# UNITED STATES PATENT AND TRADEMARK OFFICE

APPLICATION NO.	FILING DATE	FIRST NAMED INVENTOR	ATTORNEY DOCKET NO.	CONFIRMATION NO.
10/775,783	02/10/2004	Marcel E. Crettet IV	POSPAT001US	9367
7590 01/20/2006			EXAMINER	
John R. Casperson PO Box 2174 Friendswood, TX 77549			EARLY, MICHAEL JACOBY	
			ART UNIT	PAPER NUMBER
			3744	
DATE MAILED: 01/20/2006

**Office Action Summary**

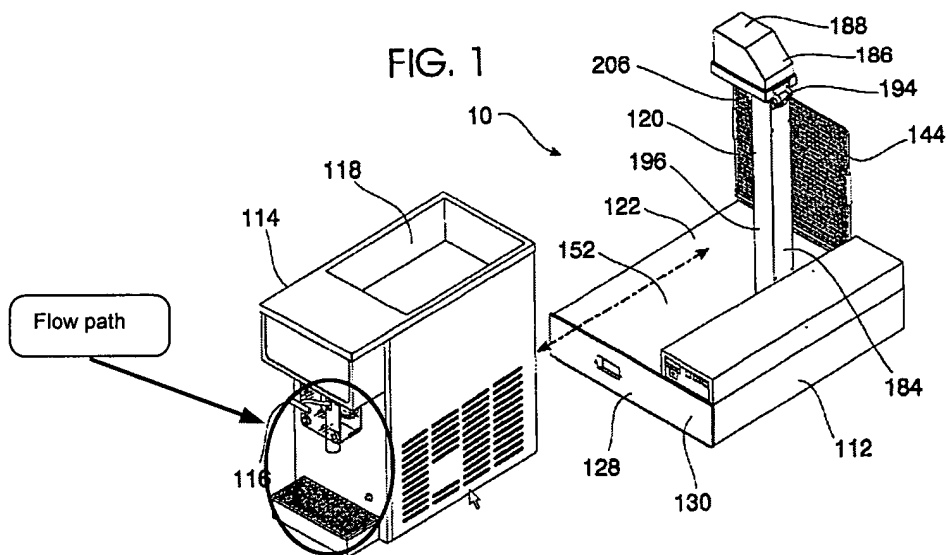
- a reservoir means comprising of:
  - an upper and lower portion (as seen in the illustration of Figure 2 below);
  - a collapsible bag (158 – flexible membrane bag);

- a sidewall supporting the collapsible bag (as seen in the illustration of Figure 5 below) that is:
    - thermally insulated (see page 2, paragraph 0043);

- of one-piece construction (as seen in Figure 5);
- a refrigeration means comprising of:
  - a chiller (124 – cavity) that has:
    - a chiller surface (as seen in the illustration of Figure 5 below) that:

- supports a lower portion of the collapsible bag (as seen in Figures 2 and 4);
      - faces the liquid in the reservoir means (as seen in Figures 2 and 4);

- at least a portion of the chiller surface is sloped with respect to vertical (as seen in Figure 5 – the surface is at a 90°-slope with respect to the vertical direction);

- an opposed pair of chiller surface portions which are sloped with respect to vertical and form a U-bend (as seen in Figures 2, 5, 6);
  - a compressor (136 – compressor) that is positioned in the housing beneath the container (as seen in the illustration of Figure 5 below) and comprises:

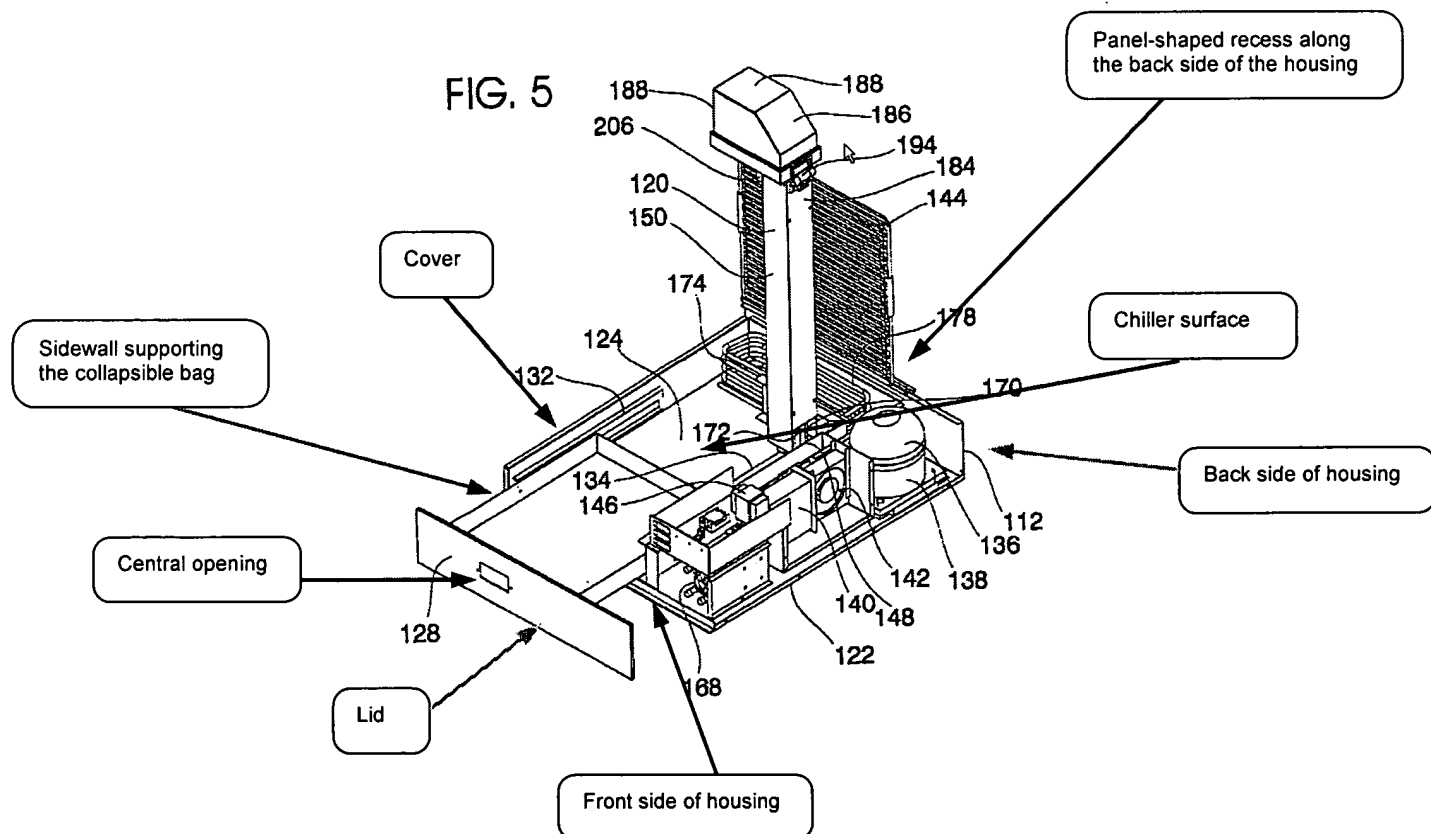
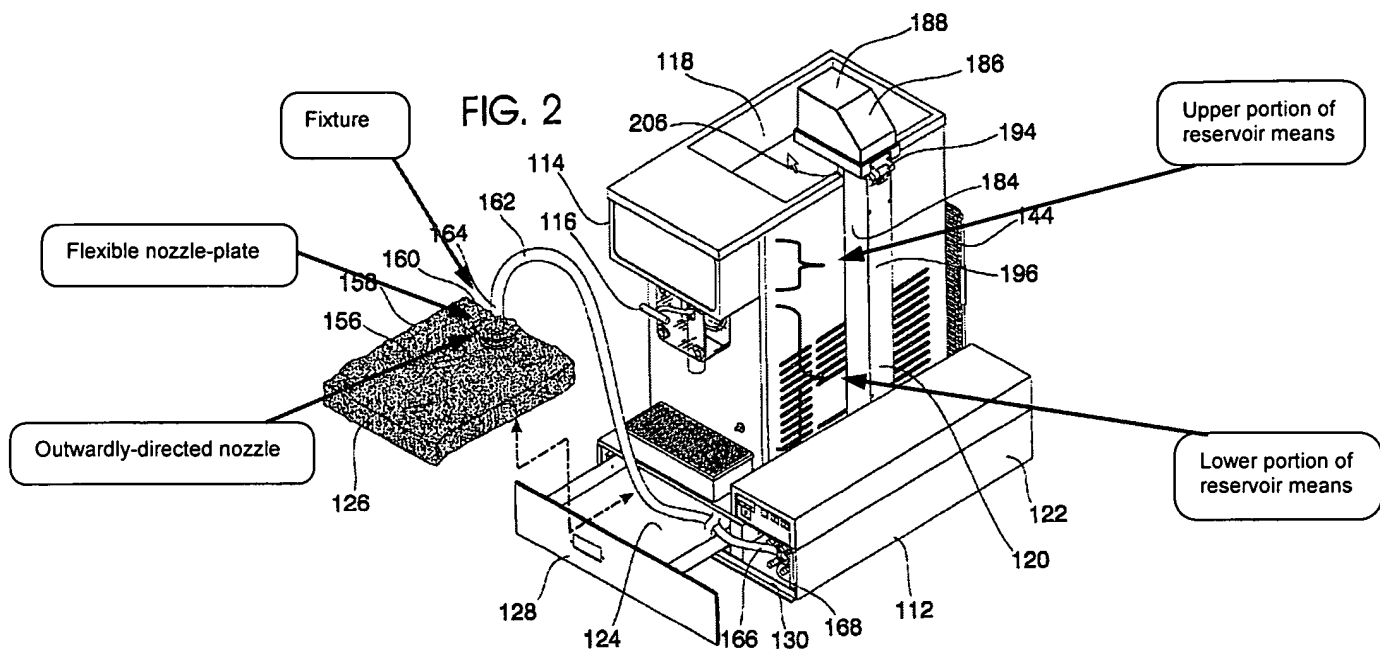
- a sensor and alarm device (sensor) which both are operatively associated with an inside of the container (see page 3, paragraph 0056);
- a condenser coil (144 – condenser coils) that is:

- positioned in a panel-shaped recess along the back side of the housing (as seen in the illustration of Figure 5 below);
  - panel-shaped (as seen in Figure 5);

- a dispenser means comprising of:
  - a flow path (as seen in the illustration of Figure 1 below) that:
    - flows from the lower portion of the reservoir means to an outside of the cooler and dispenser unit (as seen in the Figures 2 – 7);

- includes a fixture (as seen in the illustration of Figure 2 below) that:
      - is carried by the sidewall of the collapsible bag (as seen in Figures 2 and 4);

- includes a flexible nozzle-plate (as seen in the illustration of Figure 2 below) having:
        - greater rigidity than the sidewall on which it is carried (inherent);

- an outwardly facing surface (as seen in Figure 2);
        - at least one outwardly-directed nozzle on the outwardly facing surface (as seen in the illustration of Figure 2 below);

- a housing (122 – housing) that:
  - supports the chiller (as seen in Figure 5);
  - has a front side and back side (as seen in the illustration of Figure 5 below);

- a container (128 – drawer) that:
  - is positioned and slidably received in front side of the housing (as seen in Figure 5);

- a lid (as seen in the illustration of Figure 5 below) that:
  - is positioned on the upper end of the sidewall supporting the collapsible bag (as seen in the illustration of Figure 5 below);
  - has a central opening (as seen in the illustration of Figure 5 below);
- a cover at least partially laterally surrounding the housing, the chiller and the sidewall supporting the collapsible bag (as seen in the illustration of Figure 5 below);
